Re: Essex Pastures
Ipswich, MA

Bayside is in receipt of the Town's Peer Review consultant (TEC) letter dated September 7, 2018 on the Comprehensive Permit Application for the Essex Pastures project located on Essex Road (Route 133) in Ipswich, MA. This letter has been prepared to respond to the comments. The peer review comments are italicized in bold and the responses follow.

Figure 4
 2025 Build
 Peak Hour Traffic Volumes

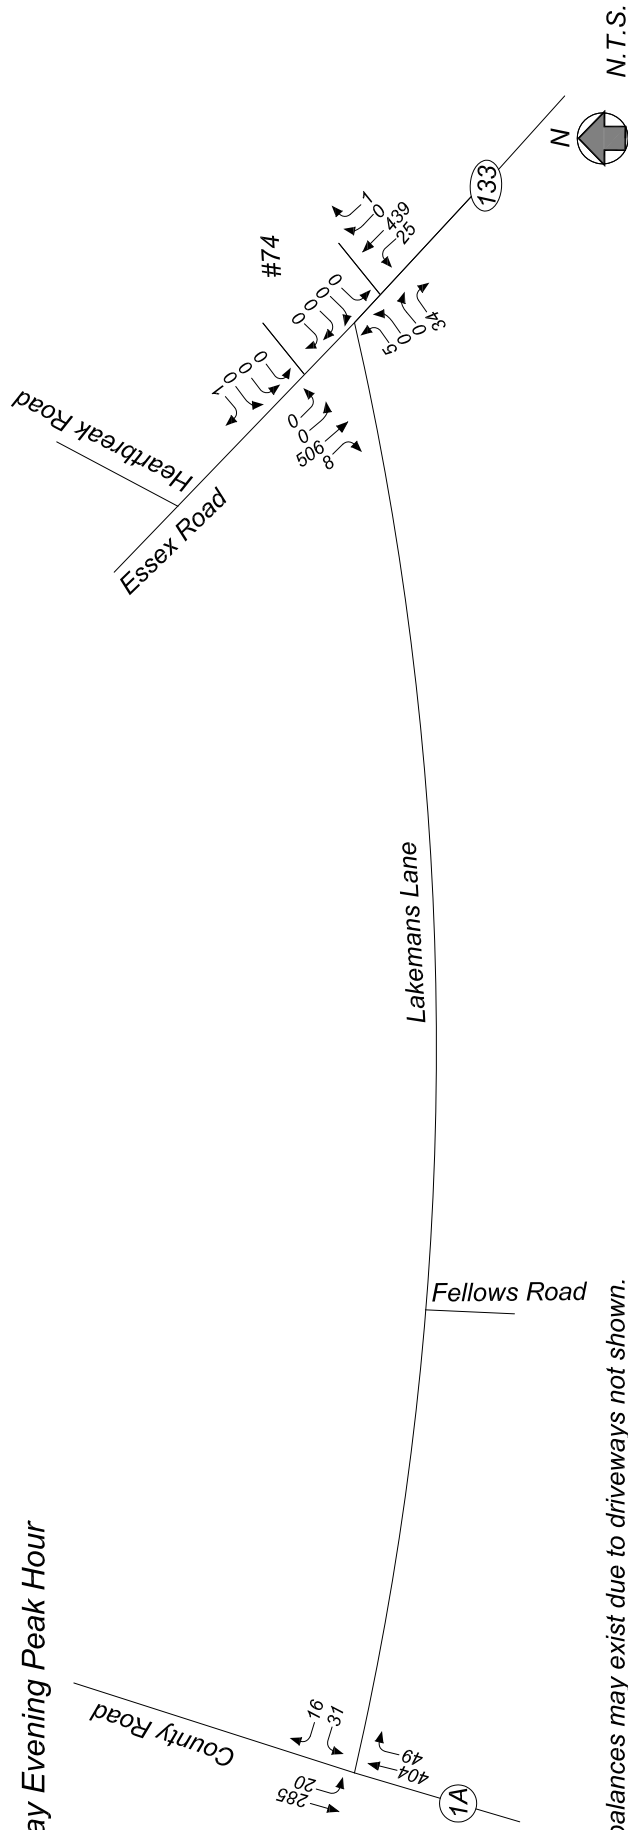
TEC notes that a portion of the site generated traffic (27%) is distributed to the east via Essex Road. The volumes are shown in the Site Generated Trip Figures 7 and 8 in the TIAS and the July 9 Memo. However, these volumes are not carried through the intersection of Essex Road / Lakeman's Lane in the Lakeman's Memo. The Applicant should review the site distributions and revise the analyses at the intersection of Essex Road / Lakeman's Lane as necessary.

Response: Included in the Appendix to this letter are the revised traffic flow networks, capacity analysis calculations and revised level of service summary table. The level of service results are not significantly changed.

Figure 5
 2025 Build Sensitivity
 Peak Hour Traffic Volumes

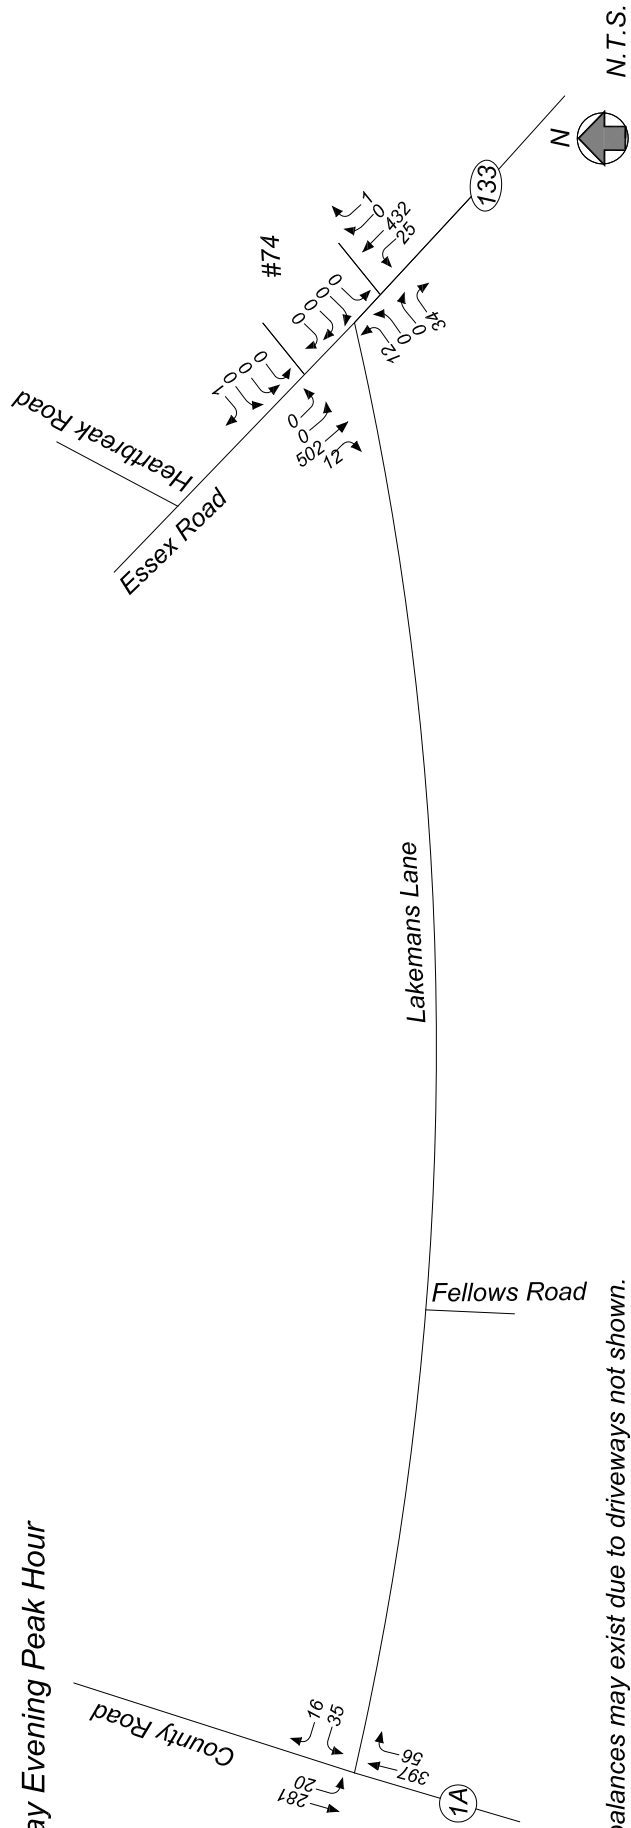
- 11. The Lakeman’s Memo performed a sensitivity analysis of the operation of the intersections of Lakeman’s Lane with Essex Road and County Road should up to 50% of the site traffic to/from the south on County Road (Route 1A) use this roadway as a cut-through. TEC performed travel time runs on the two routes to the site – via Lakeman’s Lane and via County Road. TEC concurs with the findings within the Lakeman’s Memo that the average time to/from the site via Lakeman’s Lane is approximately one minute longer than the route via County Road. The two intersections studied continue to operate at acceptable levels of service within the sensitivity analysis with the addition of site generated traffic.***
